City of Surrey
PLANNING & DEVELOPMENT REPORT

File: 7912-0071-00

Planning Report Date: November 26, 2012

in order to permit the development of a 4-storey, 27-unit apartment building.

1 NORTH ELEVATION
1/8"=1'-0"

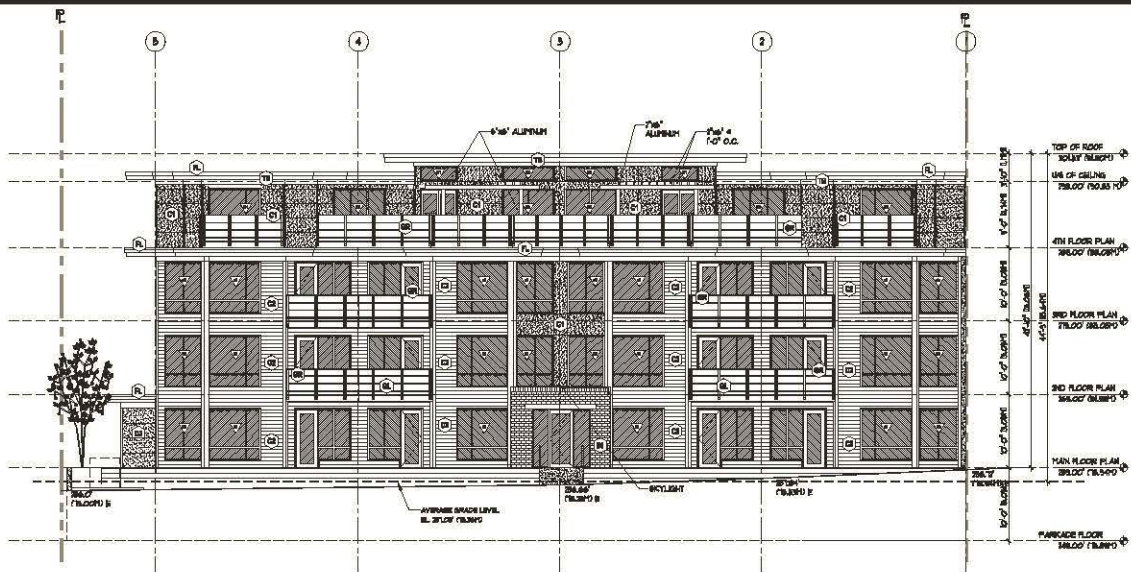
- No issue with massing. Colour weak. Top celebrates but lower proportion is repetitive and weak. Building sits low compared to the street/sidewalk elevation. Look at how the building may be raised slightly and/or pull the lower patios out to provide a more 'open' front.

- Consider redesigning the entry element to appear as a stronger architectural form.

- Look at bringing the 'green' colour down vertically to get rid of the 'wedding cake' look.

(The building main floor elevation has been raised 6 inches. The building is not sitting below the street, that is an illusion created by the 3D model. The teal accent color now runs vertically down the building to the main entrance and is also used on the exit stair element on the east side of the building.)

(The entrance brick now extends forward on both sides of the entry and projects out past the building face to frame an outside entry court. The glass canopy flies over the entry brick detail. The brick detailing of the entry is reflected in the fence enclosure along the street. The strong teal color now extends vertically down the north façade to the main entry.)

(The teal color now runs vertically on the building at the main entry.)

SCALE: 1/8"=1'-0"	PROJECT NO: _____
DATE: 01 NOV 2011	DRAWN: _____
DRAWN: RLB	SHEET: _____
REVISIONS:	DP-5.21

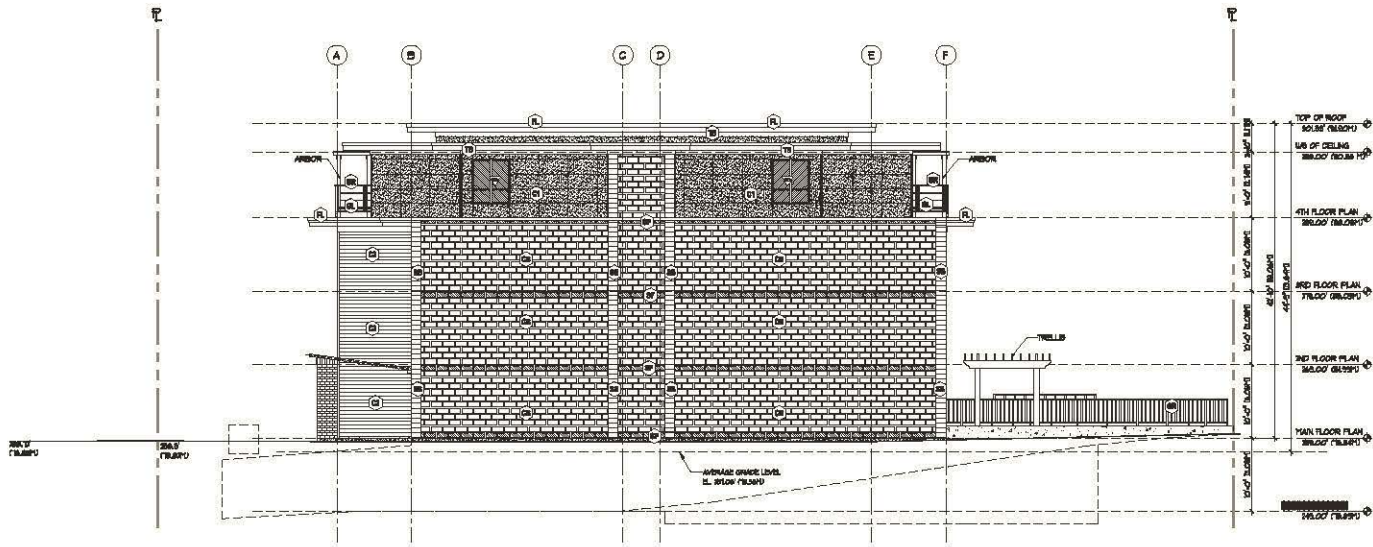
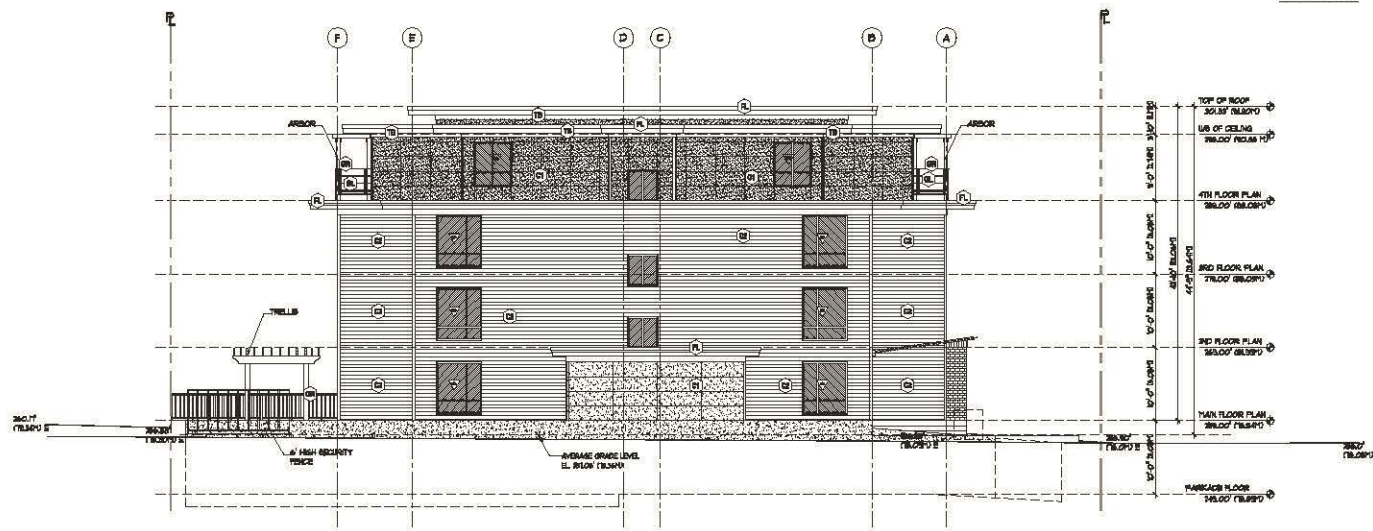
- Consider improving east elevation. Windows?

(Windows have been added to the exit stair landings and the strong teal color is being used on the projecting exit stair element.)
